Project: **BOTANICAL NORTHBOURNE AVE TURNER ACT 2612 (BLOCK 4 SECTION 07) COUNTRY: GUNGAHAL**

Drawing Name: **FLOOR PLAN - BASEMENT 1**

SCHEDULE OF REVISIONS FROM APPROVED S165C 04/11/2024 AND S205E 26/11/2024

Drawing Name
FLOOR PLAN - BASEMENT 2

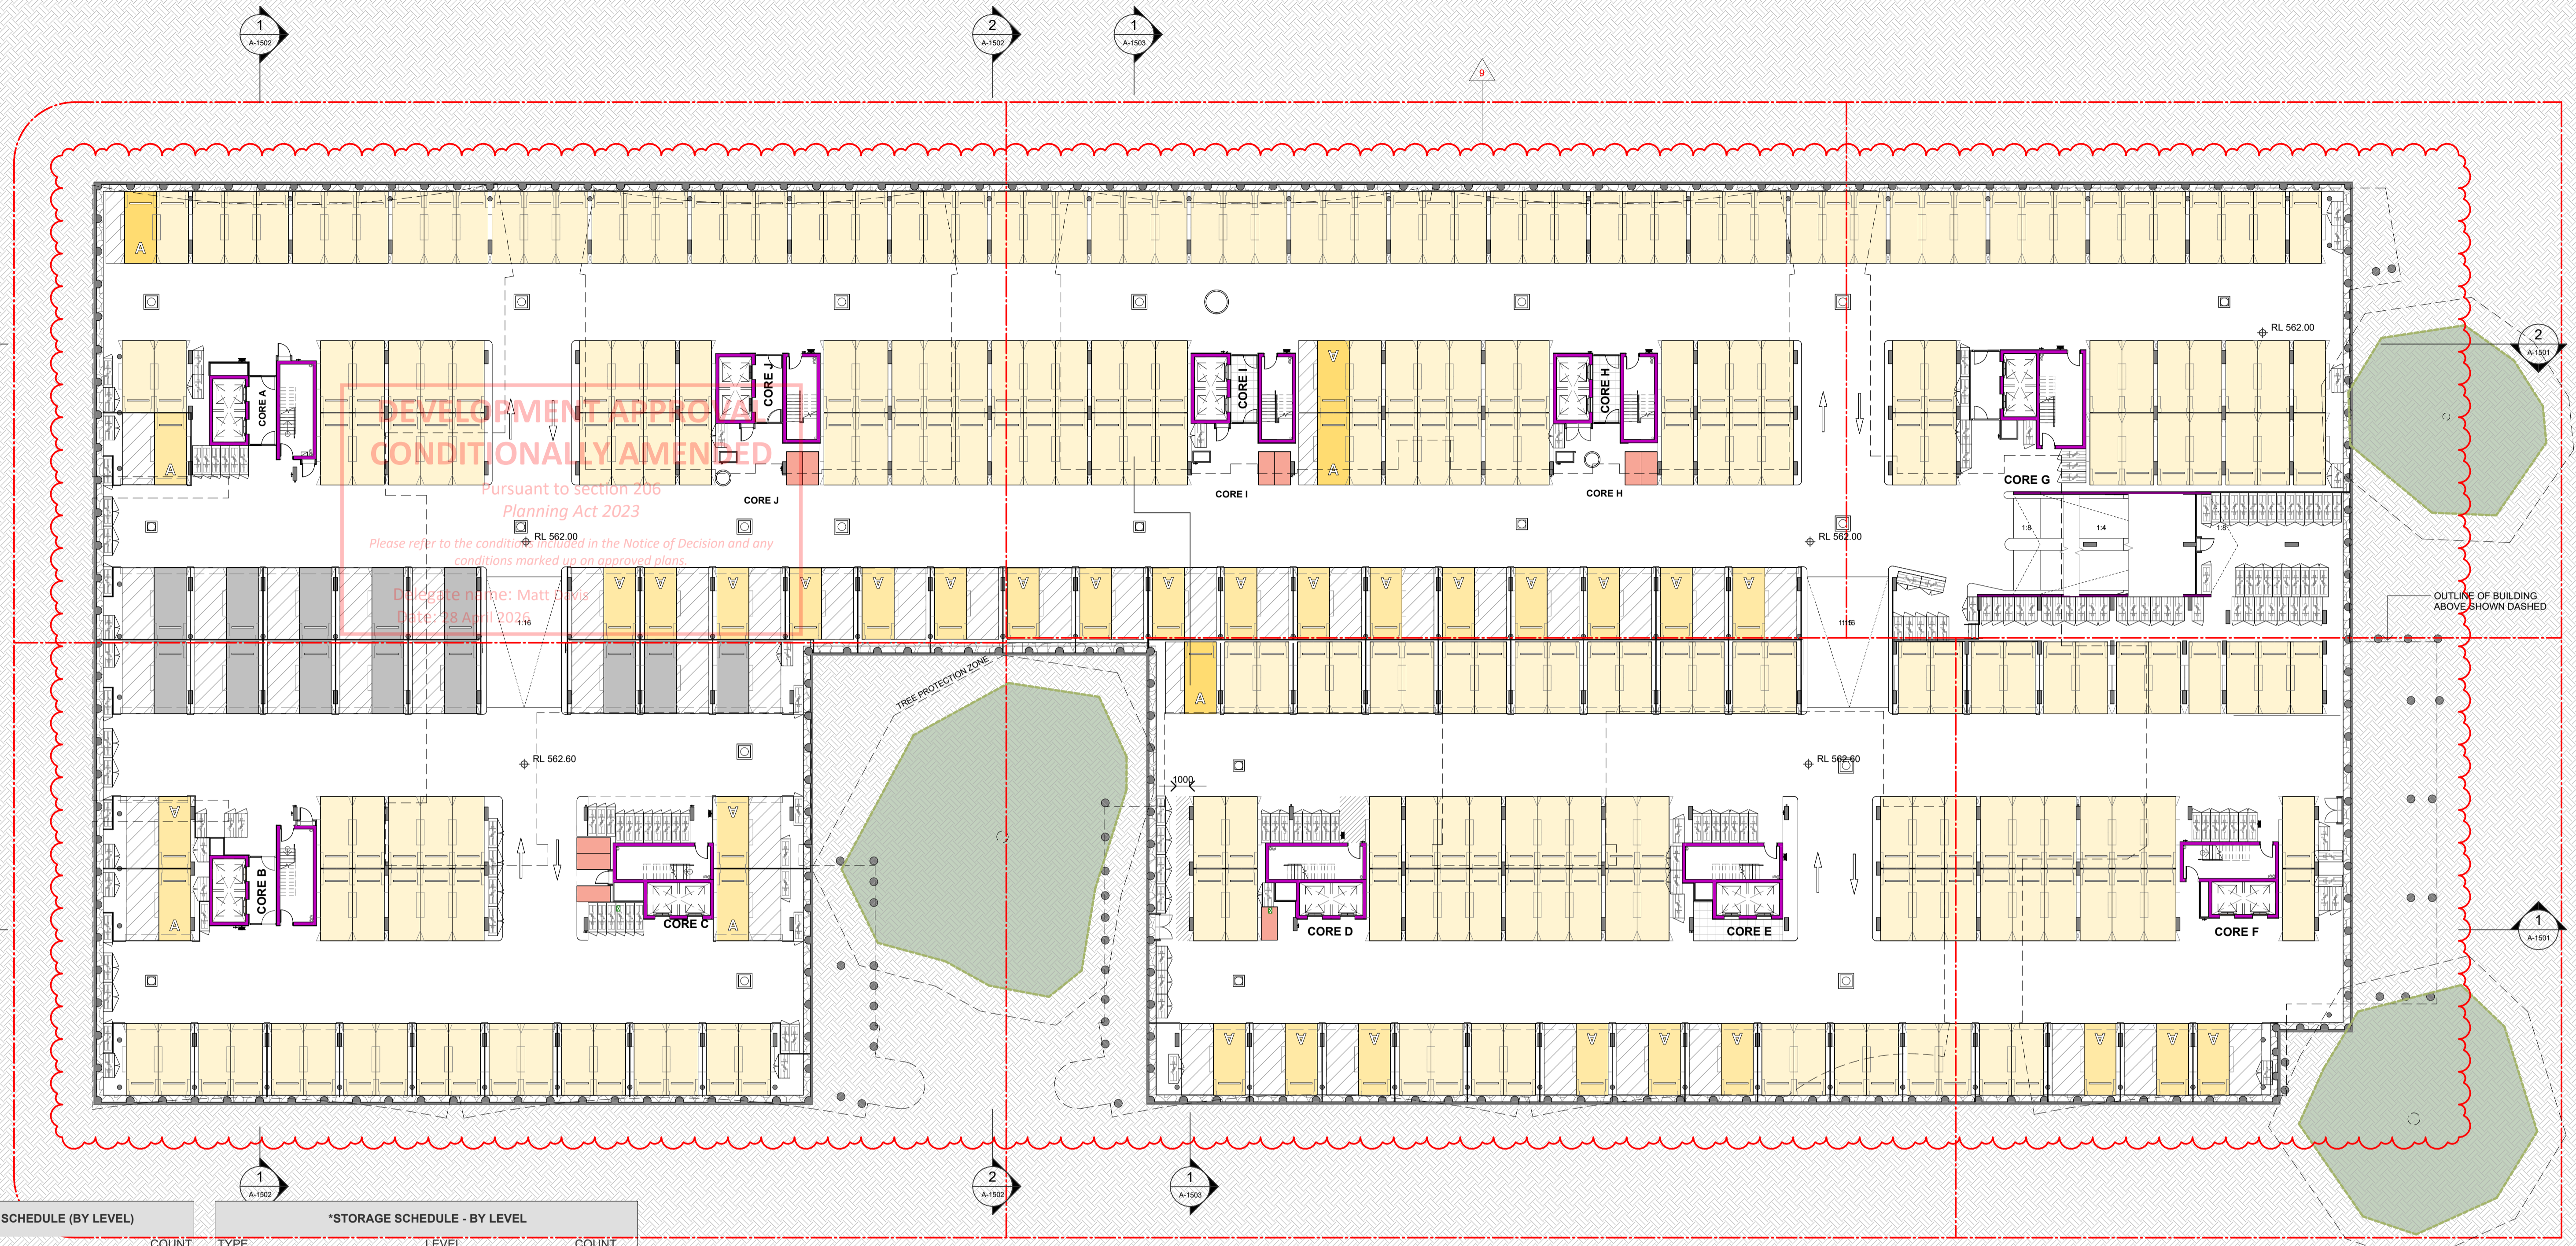
SCHEDULE OF REVISIONS FROM APPROVED S160C 0411/2024 AND S205E 2611/2024

- APARTMENT LAYOUTS GENERALLY**
 - Minor revision of internal layouts including some minor changes to facade glass lines and window positions. Some subsequent minor changes to apartment floor areas.

- FACADES GENERALLY**
 - a. Revision to increase bare concrete facades to maintain horizontal banding design intent.
 - b. Division of protruding slab edges at Level 1 Block facades and balconades.

- c. Precast grating and slurring grooves developed.
 - d. Additional vertical ventilation to some glazing to accommodate down pipes and glass panel sizes.

- e. Precast concrete finish revised to a single colour to comply with NCC and waterproofing requirements.
 - f. Metal cladding over spandrel between vertically stacked windows instead of exposed slab edge to facilitate improved weatherproofing outcomes.

- ROOF HEIGHTS**
 - a. Increased roof R/Lc by 50mm to allow for insulation and services.
 - b. Reduced IR overhang heights by 150mm to meet requirement of IR manufacturer.

- c. Parapet heights standardised resulting in lower parapet heights in some instances.
- ROOF LAYOUTS**
 - a. Revisions to extent and height of rooftop louvre screens to accommodate roof air conditioning plant locations.

- b. Revisions to position of awnings to suit revised apartment layouts.
 - c. Rooftop exhaust and intake fans, cowls and ducts.
 - d. PVC cell array deleted from Building A, G, H, I, J roofs.

- BUILDING G STRUCTURE AND ENVELOPE**
 - a. Extent of external walls around Fire Brigade Booster Valve increased to West to accommodate structural column.

- b. Double swing door in lieu of double to FREY area West facade.
 - c. Development of louvre screens and vertical louver doors for substitution, car park and loading dock.

- d. Revised column arrangement to Building G commercial external terrace to accommodate transfer of structure above.
 - e. Increased slab thickness and edge beam thickness along North and West facade to accommodate transfer and conceal services and soffit ceiling only.

- f. Level 2 girder roof extent revised to provide improved weatherproofing outcomes to the facade below.
- BUILDING H LAND STRUCTURE**
 - Increased slab thickness and edge beam thickness by 50mm locally at curved balconies to support cantilever.

- BUILDING I LAND STRUCTURE**
 - Level 5 facade columns - two individual round concrete columns in lieu of single column with double rounded face and adjustment to glazing to suit to facilitate improved weatherproofing outcomes.

- COMMUNAL AREA LAYOUTS**
 - a. Building G Sauna, spa, steam room and pool layout developed including air lock entry to communal deck.
 - b. Level 1 Communal Room Layout and floor areas revised, additional window to suit new layout.

- BASEMENT LAYOUTS GENERALLY**
 - Lobbies added to Cores A, B, G, H, I, J as requested by ACTFER. Minor revisions to layout of storage, storage cages and parking positions to accommodate.

- SIGNAGE INDICATED**
 - Signage intent drawing included and signage indicated in plans and elevations.
- WINDOW SIZES/POSITIONS**
 - Window sizes and positions revised to suit apartment layouts at all AGD1 (and all apartments above), CGD1 (and above), CGD2 (and above), EGD1 (and above), EGDA (and above) to provide improved weatherproofing outcomes.

- AREA PLANS METHOD OF MEASUREMENT**
 - Area plans revised to correct method of measurement measuring to outside face of external walls and shaft walls and centre of party walls where in previous submissions, measurements were to the inside faces of all walls.

- DEEP SOIL AND COMMUNAL OPEN SPACE**
 - Calculated areas revised due to previously approved changes to basement layout/OSD tank position (S205E) and ground floor landscaping (S205A).

- NORTHERN LANDSCAPE BUFFER**
 - Adjusted to provide additional privacy between private balconies and public path through site.
- LEVEL F PLANTER ADJUSTMENTS - for constructability, NCC compliance (no structural joints in planters for waterproofing), roof edge protection**

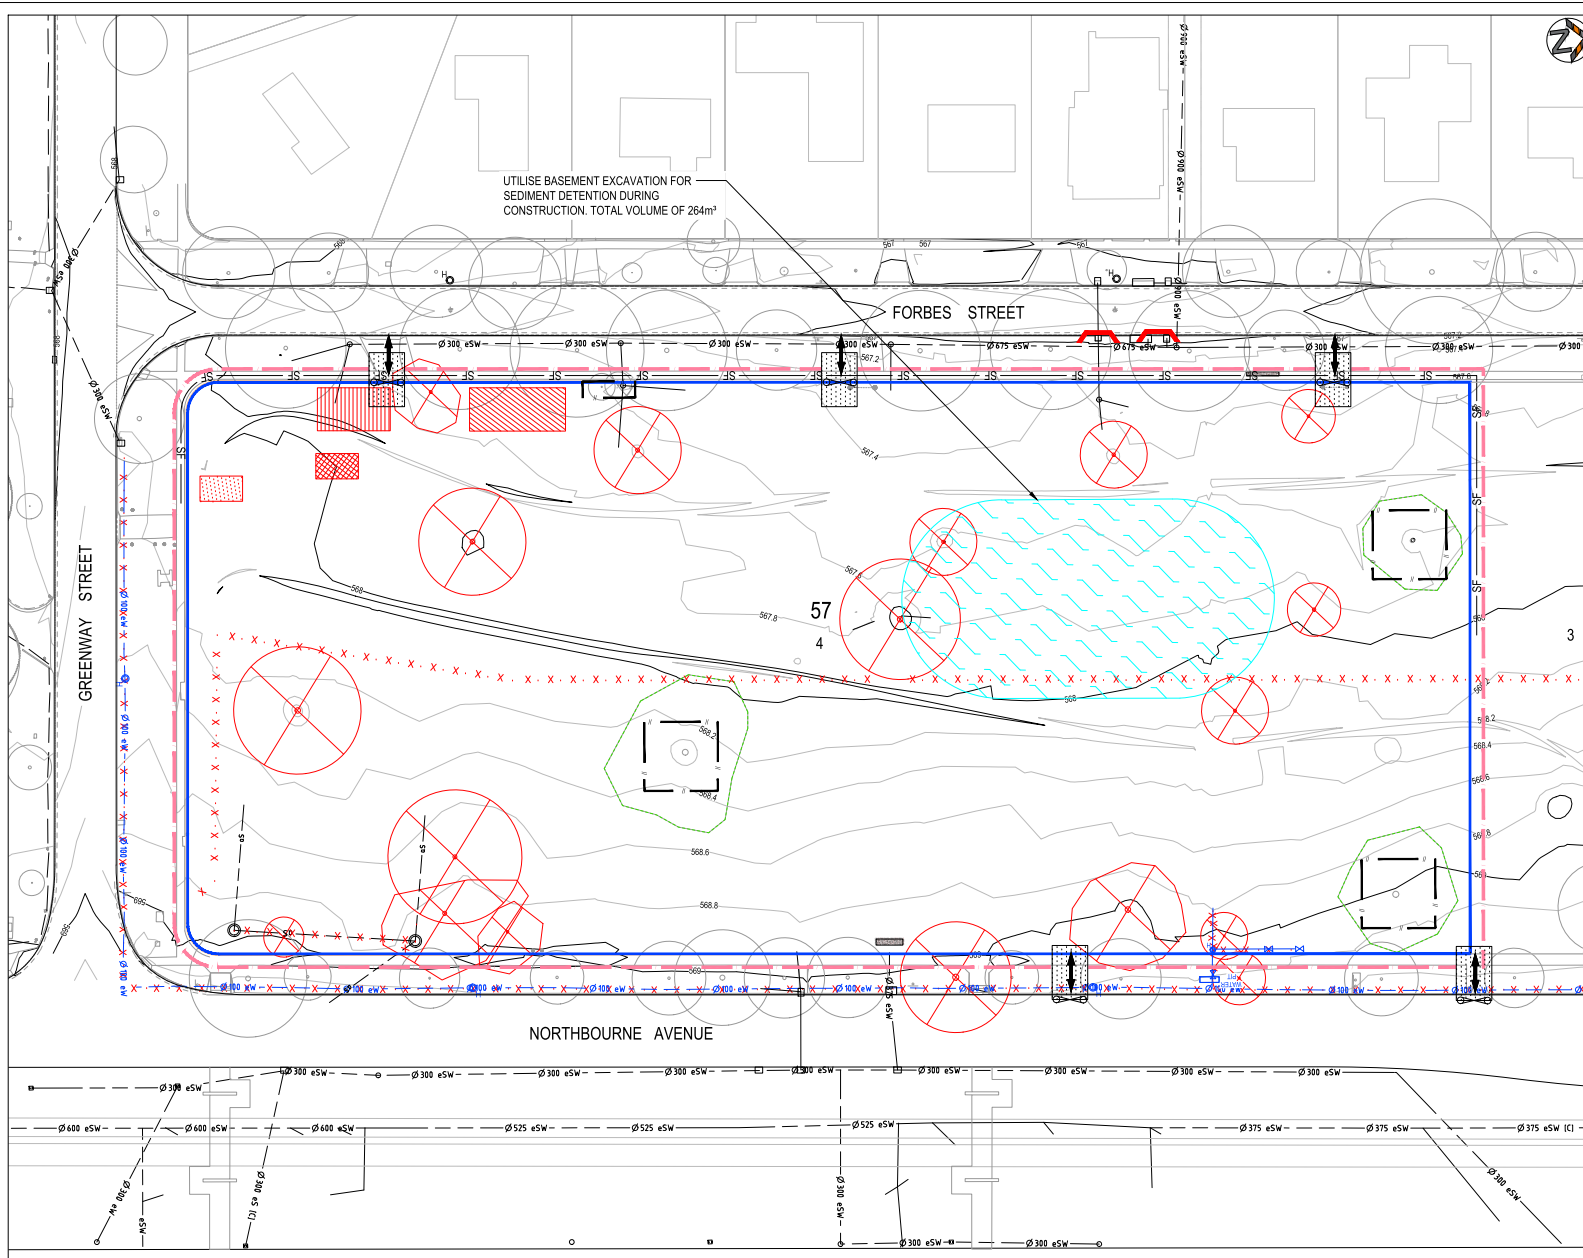
- APARTMENT LAYOUTS GENERALLY**
Minor revision of internal layouts including some minor changes to facade glass lines and window positions. Some subsequent minor changes to apartment floor areas.

- FACADES GENERALLY**
a. Revision to precast band projections at Level 2 and 7 (Level 2 and 5 for buildings H, I and J) to internal facing facades and subsequent window height changes and brick header detailing at Level 2 to facilitate improved weatherproofing outcomes.
Dummy joints added to precast concrete facades to maintain horizontal banding design intent.

b. Deletion of protruding slab edges at Level 1 Brick facades and balustrades.
c. Precast jointing and dummy grooves developed.
d. Additional vertical fenestration to some glazing to accommodate down pipes and glass panel sizes.

e. Precast concrete finish revised to a single colour to comply with NCC and waterproofing requirements.
f. Metal cladding over spanrel between vertically stacked windows instead of exposed slab edge to facilitate improved weatherproofing outcomes.

- ROOF HEIGHTS**
a. Increased roof RLs by 50mm to allow for insulation and services.
b. Reduced lift overrun heights by 130mm to min. requirement of lift manufacturer.

c. Parapet heights standardised resulting in lower parapet heights in some instances.

- ROOF LAYOUTS**
a. Revisions to extent and height of rooftop louvre screens to accommodate roof air conditioning plant locations.
b. Revisions to position of skylights to suit revised apartment layouts.

c. Rooftop exhaust and intake fans, cowls and ducts.
d. PV Cell array deleted from Building A, G, H, I, J roofs.
- BUILDING G STRUCTURE AND ENVELOPE**
a. Extent of external walls around Fire Brigade Booster Valve increased to West to accommodate structural column.

b. Double swing door in lieu of louvre to FBV area West facade.
c. Development of louvre screens and vertical batten doors for substation, car park and loading dock.

d. Revised column arrangement to Building G communal external terrace to accommodate transfer of structure above.
e. Increased slab thickness and edge beam thickness along North and West facade to accommodate transfer and conceal services and soffit ceiling cavity.

f. Level 2 planter roof extent revised to provide improved weatherproofing outcomes to the facade below.
- BUILDING C AND D STRUCTURE**
Increased slab thickness and edge beam thickness by 50mm locally at curved balconies to support cantilever.

- BUILDING H, I AND J STRUCTURE**
Level 5 facade columns - two individual round concrete columns in lieu of single column with double rounded face and adjustment to glazing to suit to facilitate improved weatherproofing outcomes.

- COMMUNAL AREA LAYOUTS**
a. Building G Sauna, spa, steam room and pool layouts developed including air lock entry to communal deck.
b. Level 1 Communal Room Layout and floor areas revised, additional window to suit new layout.

- BASEMENT LAYOUTS GENERALLY**
Lobbies added to Cores A, B, G, H, I, J as requested by ACTF&R. Minor revisions to layout of services, storage cages and parking positions to accommodate.

- SIGNAGE INDICATED**
Signage intent drawing included and signage indicated in plans and elevations.
- WINDOW SIZE/POSITIONS**
Window sizes and positions revised to suit apartment layouts at unit AG01 (and all apartments above), CG01 (and above), CG06 (and above), EG05 (and above), FG04 (and above) to provide improved weatherproofing outcomes.

- AREA PLANS METHOD OF MEASUREMENT**
Area plans revised to correct method of measurement measuring to outside face of external walls and shaft walls and centreline of party walls where in previous submissions, measurements were to the inside faces of all walls.

- DEEP SOIL AND COMMUNAL OPEN SPACE**
Calculated areas revised due to previously approved changes to basement layout/OSD tank position (S205E) and ground floor landscaping layouts (S205D).

- NORTHERN LANDSCAPE BUFFER**
Adjusted to provide additional privacy between private balconies and public path through site.
- LEVEL 7 PLANTER ADJUSTMENTS** - for constructability, NCC compliance (no structural joints in planters for waterproofing), roof safety and drainage.
